# FORM-BASED ZONING REPORT

▶ <b>FILE #:</b>	<b>1-B-25-OB</b>	<b>AGENDA ITEM #:</b>	<b>42</b>
POSTPONEMENT(S):	1/9/2025	<b>AGENDA DATE:</b>	<b>2/13/2025</b>
▶ <b>APPLICANT:</b>	<b>HEYOH DESIGN &amp; DEVELOPMENT</b>		
OWNER(S):	Gordon & Stacy Savage		
TAX ID NUMBER:		109 A B 008	<a href="#">View map on KGIS</a>
JURISDICTION:		City Council District 1	
STREET ADDRESS:		515 MIMOSA AVE	
▶ <b>LOCATION:</b>	<b>North side of Mimosa, west of Atchley St</b>		
▶ <b>APPX. SIZE OF TRACT:</b>	<b>7166 square feet</b>		
SECTOR PLAN:		South City	
GROWTH POLICY PLAN:		N/A (Within City Limits)	
ACCESSIBILITY:		Access is via Mimosa Avenue, a local road with 24 ft of pavement width within a 38-ft wide right-of-way	
UTILITIES:		Water Source: Knoxville Utilities Board Sewer Source: Knoxville Utilities Board	
FIRE DISTRICT:		Knoxville Fire Department	
WATERSHED:		Tennessee River	
▶ <b>ZONING:</b>	<b>SW-3 (South Waterfront, Sevier Avenue)</b>		
▶ <b>EXISTING LAND USE:</b>	<b>Single Family Residential</b>

## **Zoning Administrator Report for Level III: Alternative Compliance Review**

**515 Mimosa Avenue**

01 02 03 04 05 06 07 08 09 10 11 12 13 14 15 16 17 18 19 20 21 22 23 24 25 26 27 28 29 30 31

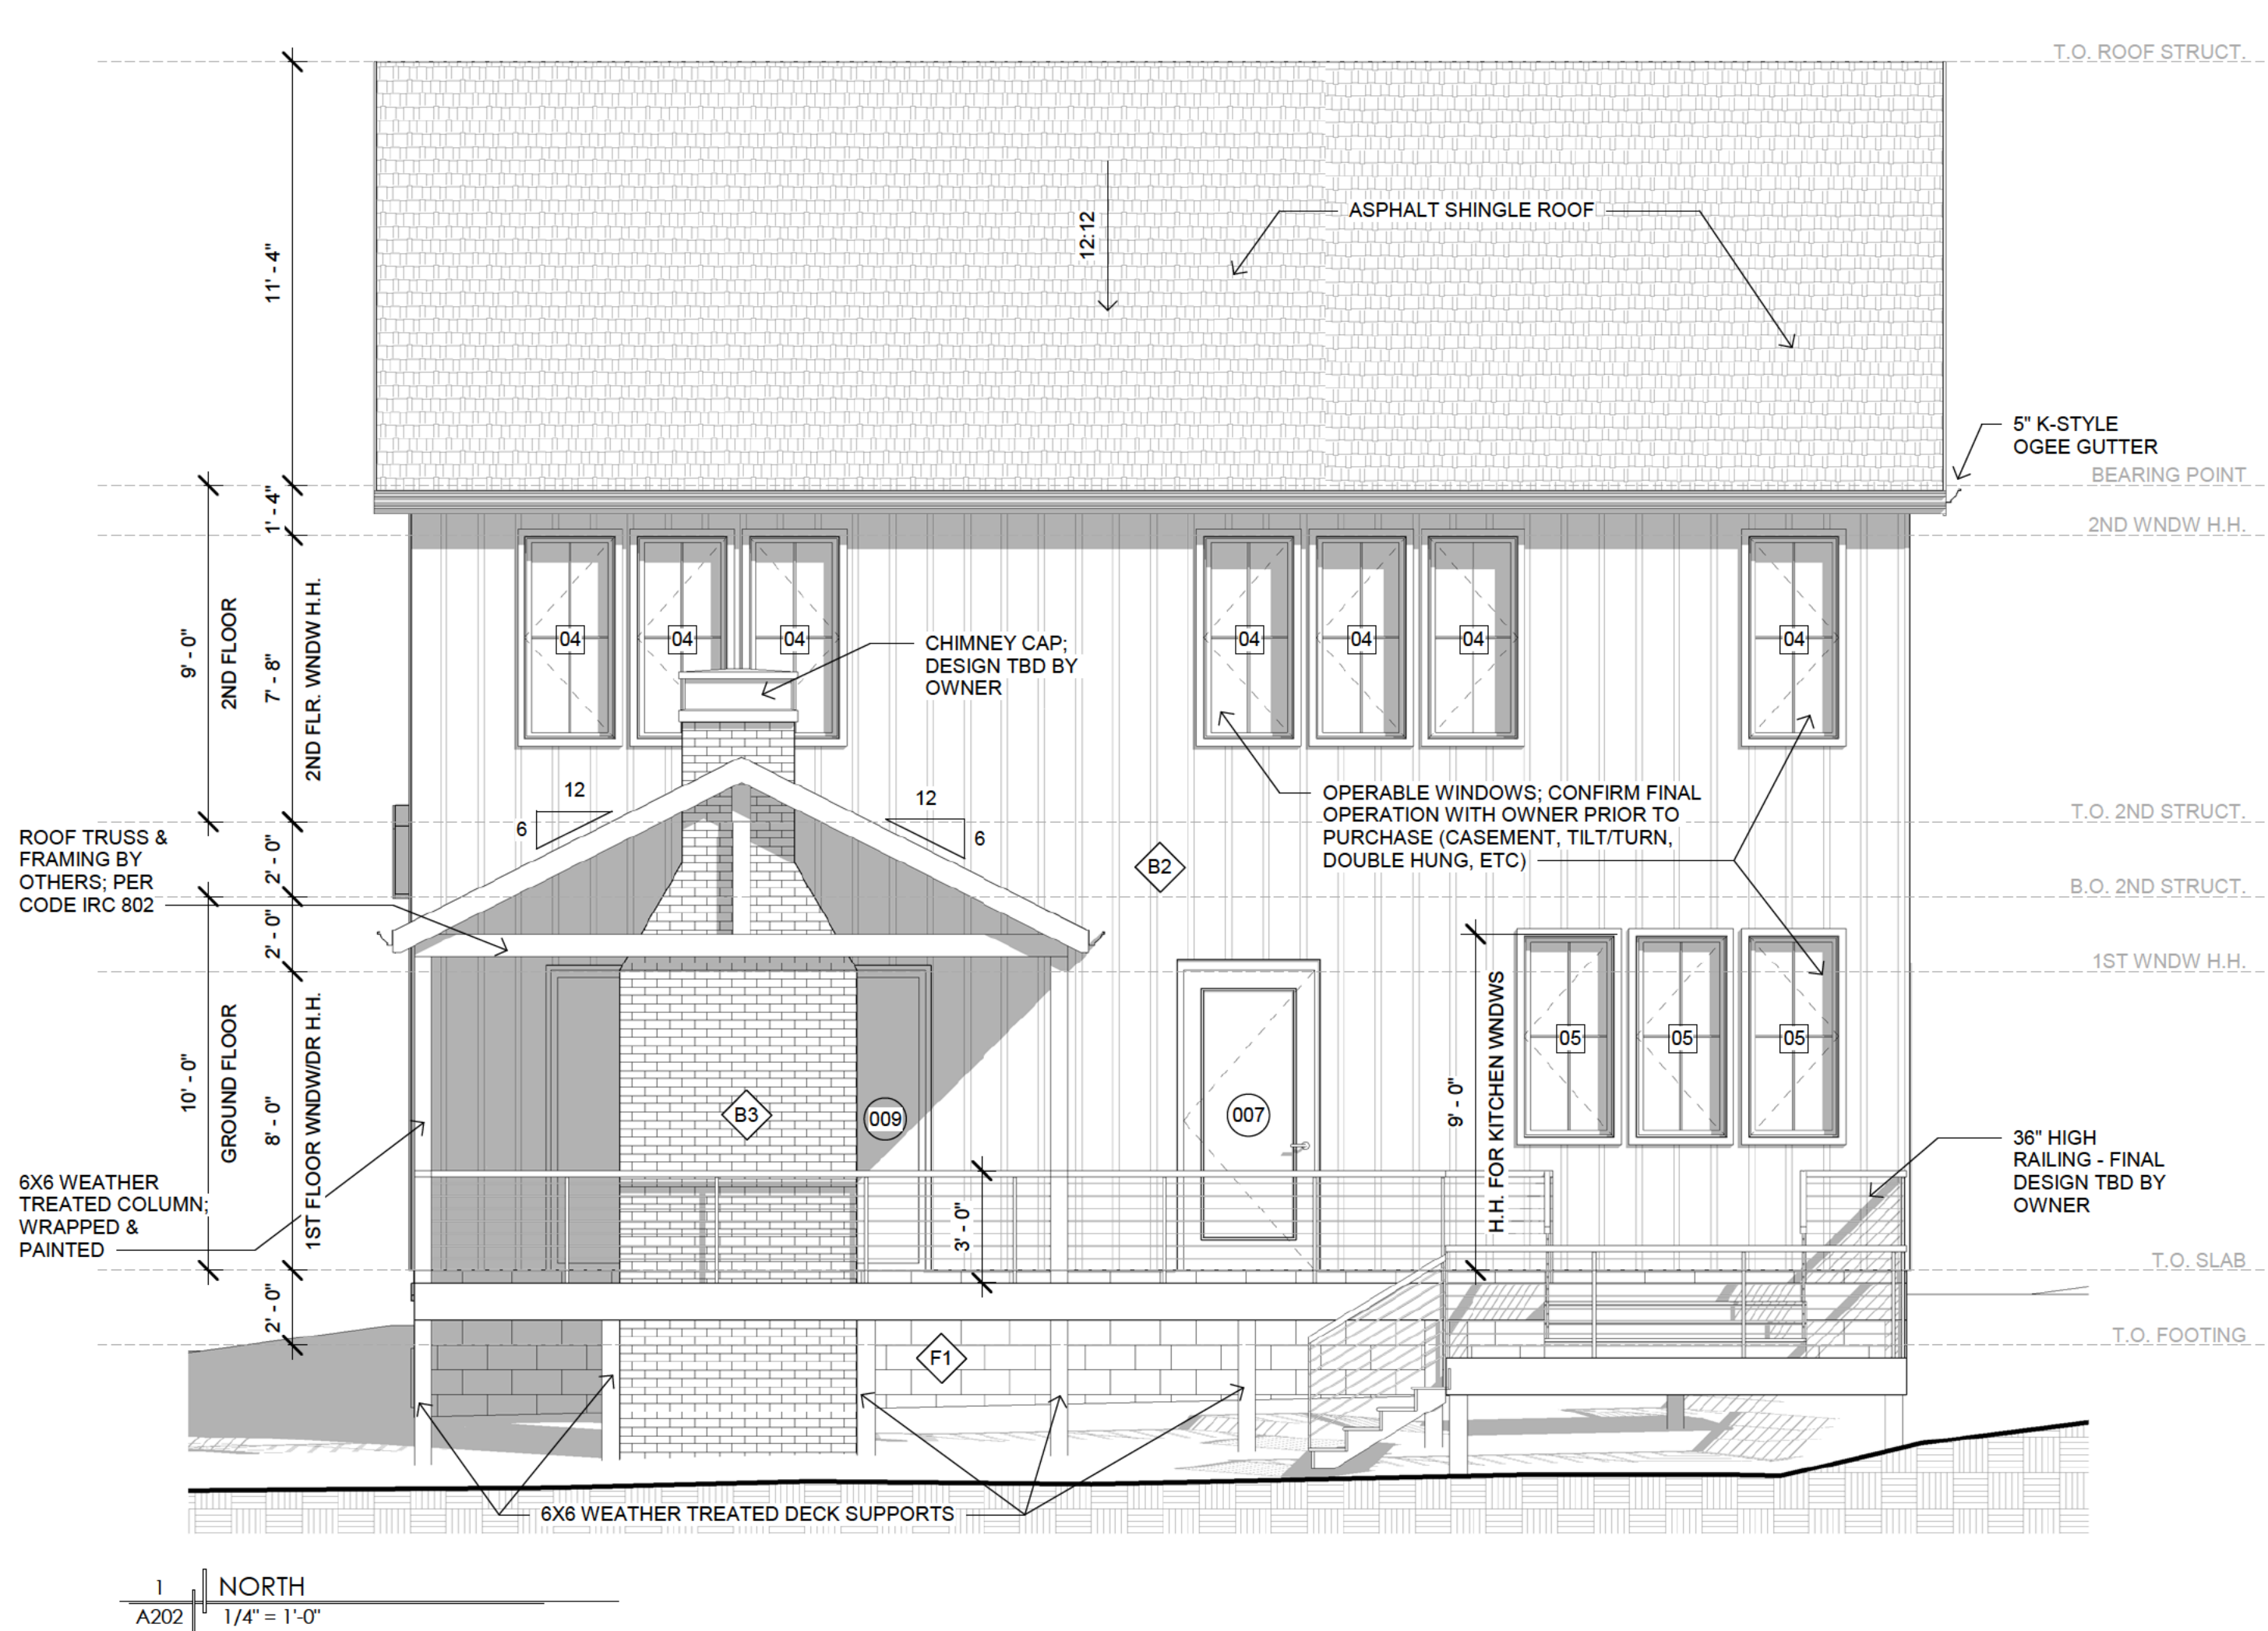
The strict interpretation of the SW-3 form based code does not allow garages to be located at the front of the property. Additionally, a reduction from the required 70% to 12.4% transparency calculation on the front façade qualifies as a Level III review because Article 7.0.2.F.8.c.i states, “No variance can be granted to reduce transparency by more than 10% in the South Waterfront District.”

The applicant is continuously working with the Administrative Review Committee to address unresolved comments. The location of the garage is not in an approved location and the level of transparency reduction cannot go through the variance process. Due to topography, the applicant has suggested they cannot utilize the rear alley to locate the garage to the rear of or underneath the dwelling and that a garage located at the front of the dwelling is the best solution to provide covered and secured off-street parking. It should be noted that parking is not required in the South Waterfront District.
